Comments on “A New Elliptical Model for Device-Free Localization”

Abstract: A recent paper “A New Elliptical Model for Device-Free Localization” (Sensors 2016, 16, 577) presents a new geometry-based elliptical model for Device-free localization (DFL). In this comment, we point out some problems of the original paper and exploit the same data used in the original paper to demonstrate the existence of these problems. Then, we give a modified formula to correct their model. Meanwhile, a real experiment is performed to verify our conclusion.

Figure 1. (a) An example of three voxels in the ellipse; (b) the simulated shadowing effect map by Formula (1); and (c) the authors' result for Formula (1) (i.e., Figure 3c in [1]).

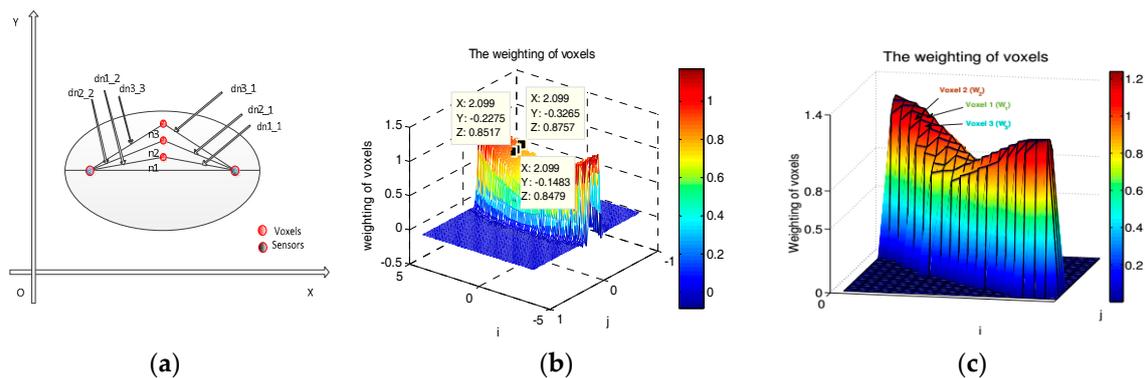
In Figure 1a, n_1 , n_2 , and n_3 are three voxels in the ellipse that they have the same abscissa. It is obvious that the weight of voxel n_3 is biggest among the three voxels according to Formula (1). Furthermore, we give the weight distribution of a link in Figure 1b, which also shows the weight of the voxel that near the LOS path is smaller than those voxels that are far from the LOS path. These phenomena show Formula (1) is conflicting to the authors' purpose. Interestingly, Formula (1) is also contradictory to the authors' result in [1]. As shown in Figure 1c (i.e., Figure 3c in [1]), it is obvious that the weight increases from the elliptical edge to LOS path of the ellipse. However, the trend of the weight in Formula (1) is not consistent with Figure 1c.

Figure 3. (a) Experimental setup; and (b) the measured shadowing effect map.

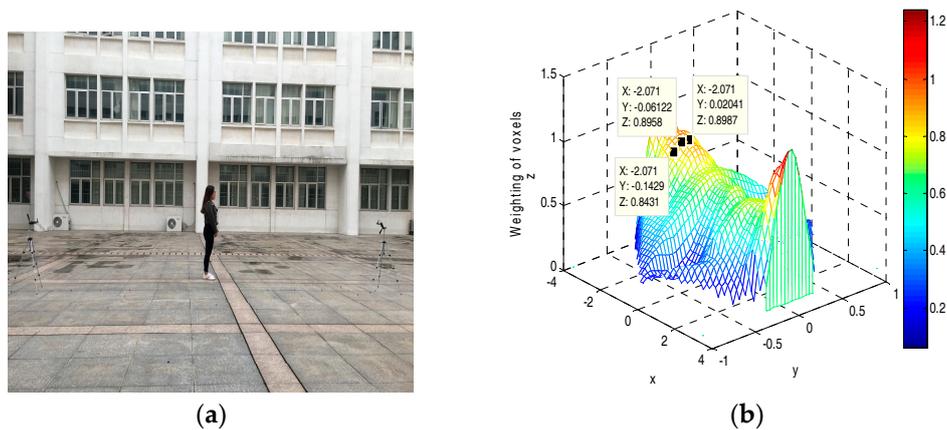
To further verify our conclusion, a real experiment is performed to validate the proposed new model. The experimental system is made up of the two wireless nodes shown in Figure 3a, and they operate on a 2.4-GHz Industrial Scientific Medical (ISM) band. From the visualized results in Figure 3b, we can see that the obtained shadowing effect map is consistent with the new elliptical model.
